N4694D-02

Modification Recommended Service Note

N4694D Electronic Calibration Module (ECal)

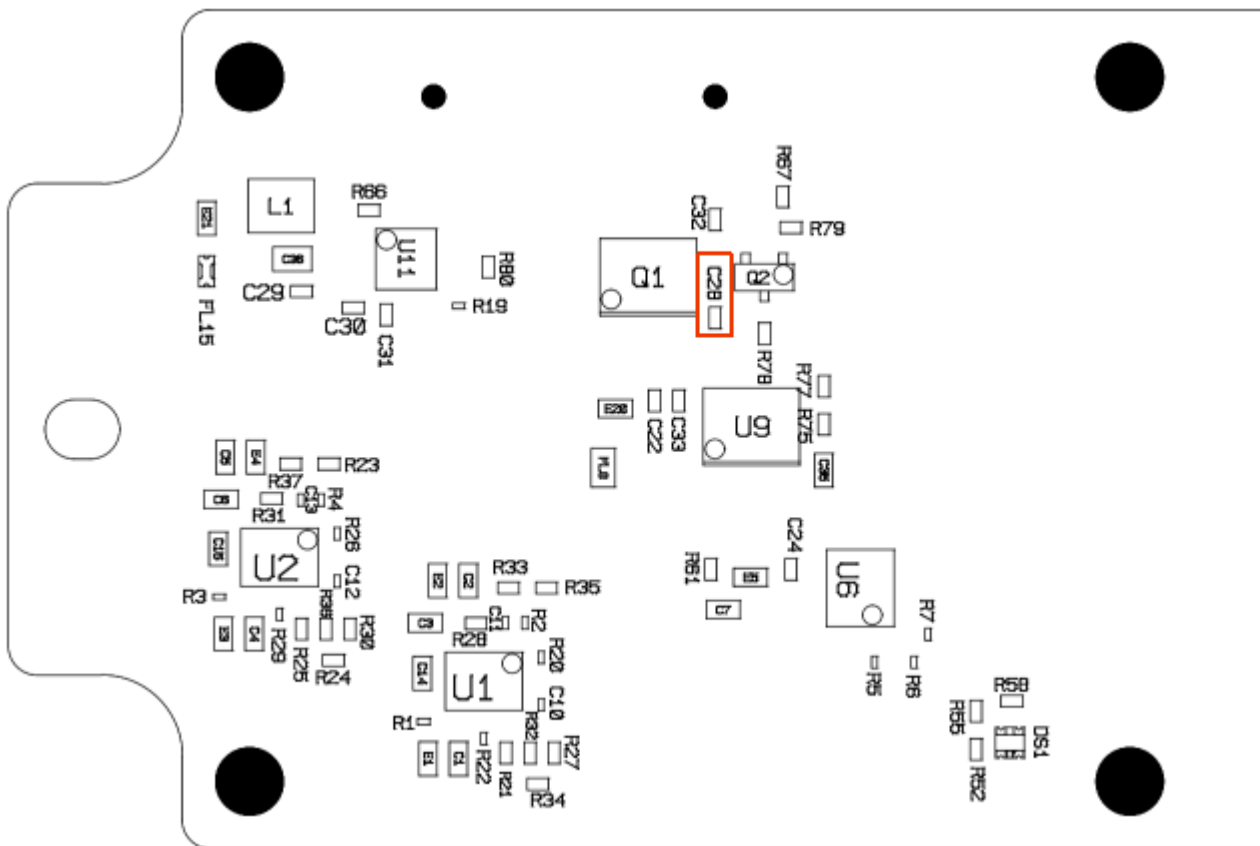
The heater circuit in the N469xD ECal modules was initially designed with a dampening capacitor. It was found in a small number of ECal modules that a resonance can develop in this circuit after the modules is warmed up. This resonance can cause an RF tone between 140 MHz and 150 MHz to be injected onto the signal path.

The dampening capacitor was eliminated in all ECal modules with serial prefix MY5941 and above.

Open the ECal module and remove the N4690-63004 printed circuit board. On this board, locate the C28 capacitor indicated here:

If this capacitor has been removed, no further action is required. Reassemble the ECal module.

If this capacitor exists on this board, this capacitor should be carefully unsoldered and removed, or the N4690-63004 printed circuit assembly should be replaced. Once this is done, reassemble the ECal module.
